## Analytical Report Regarding File: O-9426/Z-9427

Applicant: The Corporation of the City of London and 242593 Ontario Inc. (Royal Premier Homes)  
517-525 Fanshawe Park Road East

This report is to form part of the Public Record with regards to the City of London Official Plan and Zoning By-Law Amendments, Application File: O-9426/Z-9427, by the City of London and 242593 Ontario Inc., for a 6-Storey, 99 Unit Apartment Building at 517-525 Fanshawe Park Road East.

**MAP 3 - STREET CLASSIFICATIONS**

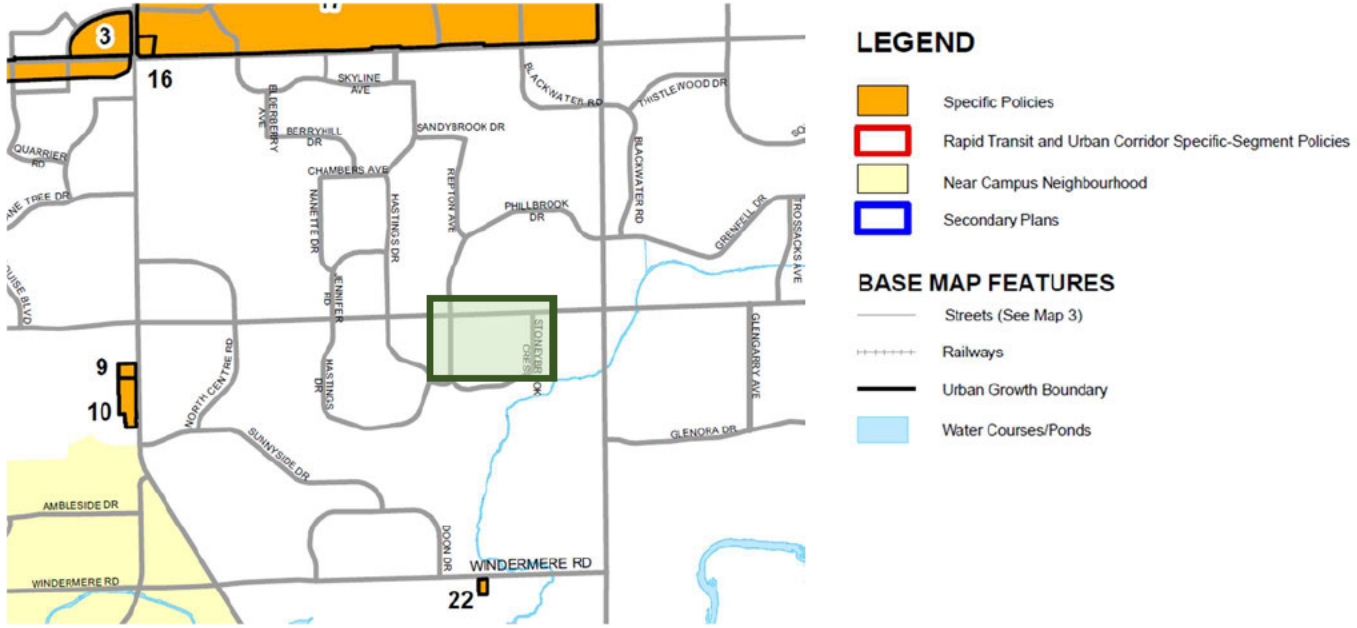
Geary Avenue is not a Neighbourhood Connector

Figure 23 - 1989 City of London Official Plan: Schedule 'A' - Land Use (Excerpt)

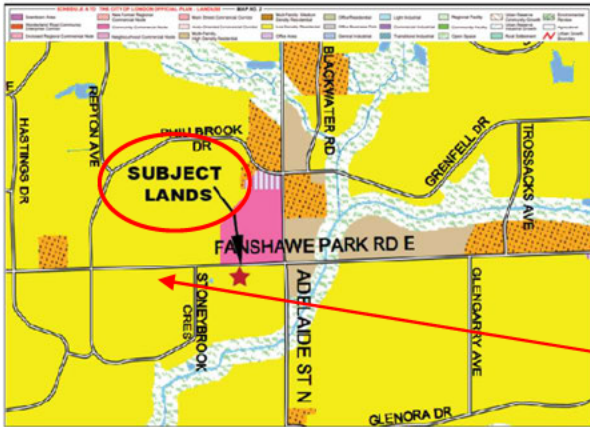
“Subject Lands” identified by the Red Star and label with leader are incorrectly identified on Page 24 of the Consultant’s Report

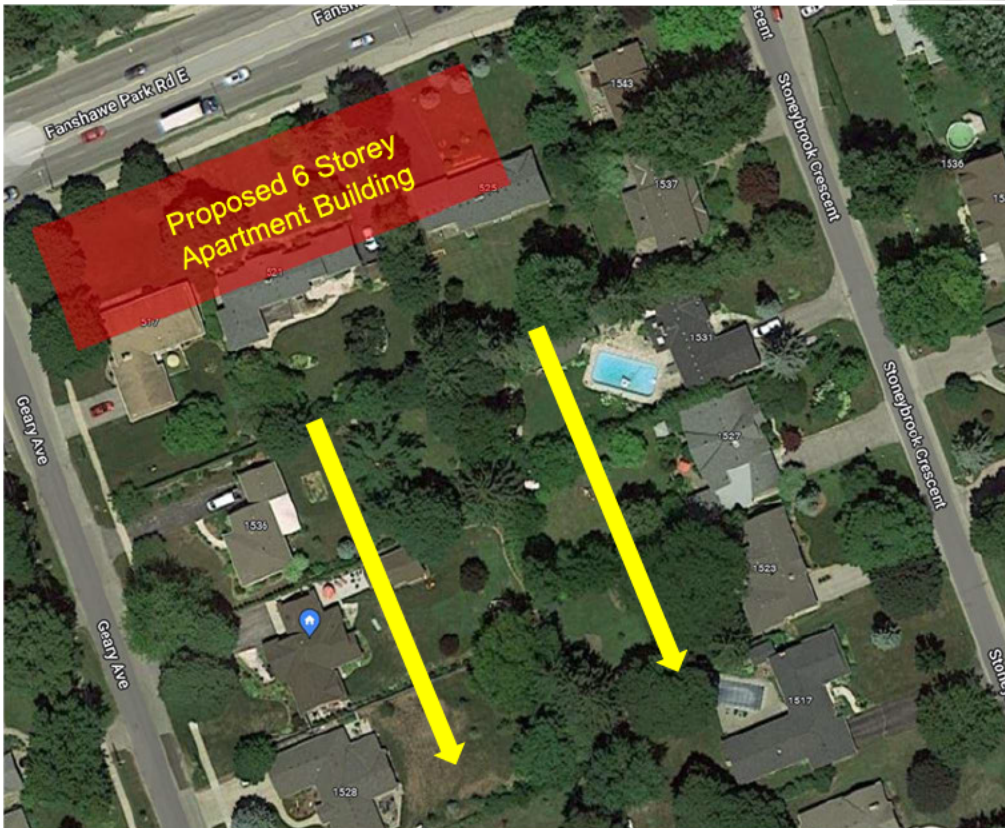
The house at 1536 Geary Avenue depicted here and as outlined above. The neighbouring house to the south at 1532 Geary out is creatively missing and the lot is fully treed / park like. This really emphasizes the lack of proper spatial separation, acceptable scaling, and respecting neighbourhood character.

1543 (side split), 1537 (two storey) & 1531 (single floor ranch) Stoneybrook Crescent (east) that abut the subject property. Much smaller in scale & height than that depicted.

Not accurate depiction of tree canopy

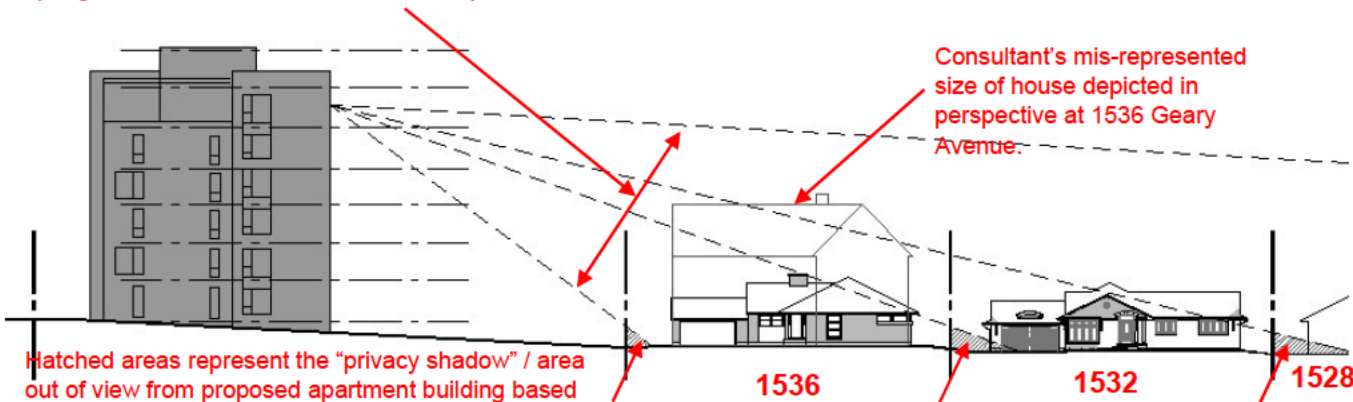
Ridge of house projects in perspective to underside of fourth floor level

Existing single floor ranch house at 1536 Geary Avenue is misrepresented & scaled to be Approximately 32' in height as extrapolated by the dashed red line. Actual height of house to roof peak is ~19'-3" per comparison & CAD files from 1532 Geary Avenue. Approximate lot grades, topographic elevations & contours have been considered & incorporated.

The scale of 6-storey proposed apartment building is being mis-represented by scaling Up / increasing the size of the surrounding single floor residential ranch homes.

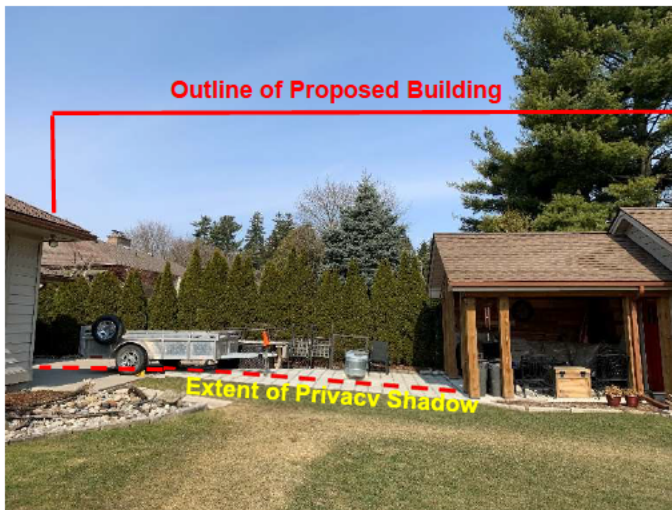
Matched areas represent the "privacy shadow" / area out of view from proposed apartment building based on an assumed ~5'-6" wood fence height. Wood fences of this nature do not exist in many of the back yards because there is spatial separation & other for privacy at the inhabited zone from grade to ~6'-0".

Consultant's mis-represented size of house depicted in perspective at 1536 Geary Avenue.
